REVIEW OF “THE NEAR-TERM MARKET AND GREENHOUSE GAS IMPLICATIONS OF FOREST BIOMASS UTILIZATION IN THE SOUTHEASTERN UNITED STATES”

Mary Booth, PhD, September 8, 2010

Figure 1. In this graph, modeled net greenhouse gas emissions are tracked through time for each region. Positive values indicate that biomass co-firing is emitting more carbon than the baseline scenario without co-firing; negative values indicate a decrease.

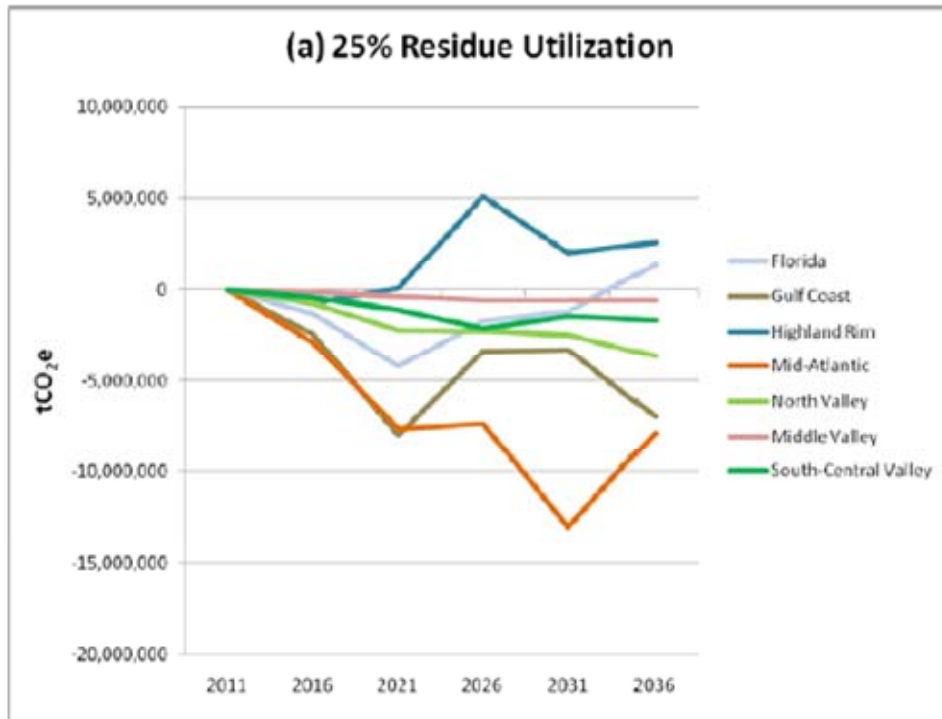
For the Southeastern co-firing scenarios, the reductions in carbon emissions from burning wood, relative to emissions from coal, are relatively small for the aggregated analysis where all woody fuels are considered equally available to every coal plant. For the regional analyses where coal plants are limited to using fuel from within a 50 mile radius, the Highland Rim analysis shows that emissions would actually be significantly *higher* with biomass co-firing than without, and for several of the other regions, the benefits in terms of carbon savings are so small as to be negligible (Figure 1). With such slim margins, it is important to check whether the assumptions behind the model give confidence that the results are robust.

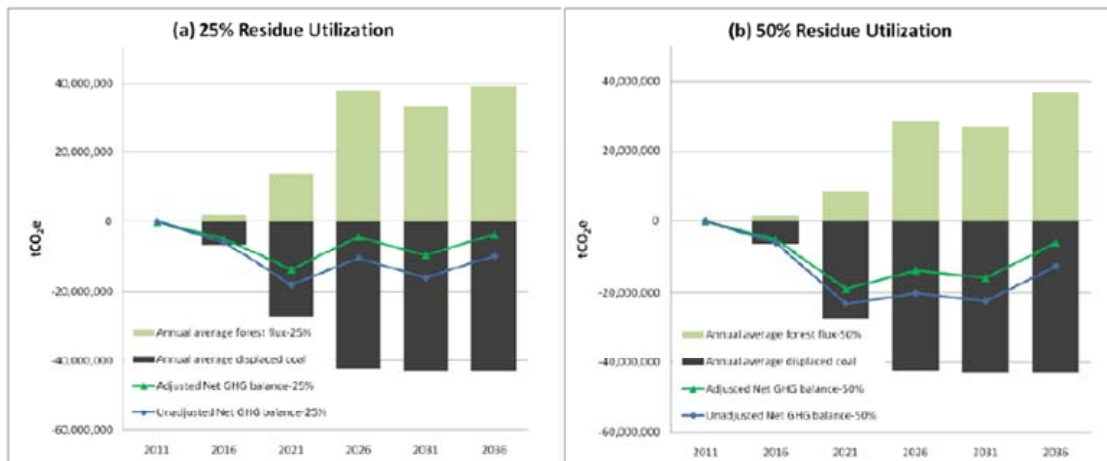
According to the ORNL Biomass Energy Data Book,¹ the lower heating value of wood at 50% moisture content is indeed about 85% of the higher heating value, thus the estimate of a 15% penalty is a more realistic estimate than the earlier estimate, and the second set of graphs showing net GHG flux though time (green line) results should be seen as more legitimate than the results reported which do not take into account the energy cost of evaporating moisture in the wood.

Considering the assumptions about wood energy content made in the study, the study’s conclusion that about 532 MMBtu of wood, or about 59 million green tons, are required to co-fire at an average rate of 10.1% is not supported. The study acknowledges that taking the 15% moisture penalty into consideration would require 68 million tons to meet fuel needs, but with an average heat content of 8,600 Btu/lb of bone dry wood instead of 9,000 Btu/lb as the study assumes, the lower heating value of wood at 50% moisture content is 3,775 and it would require 70.46 million tons of wood to produce the Btus required.
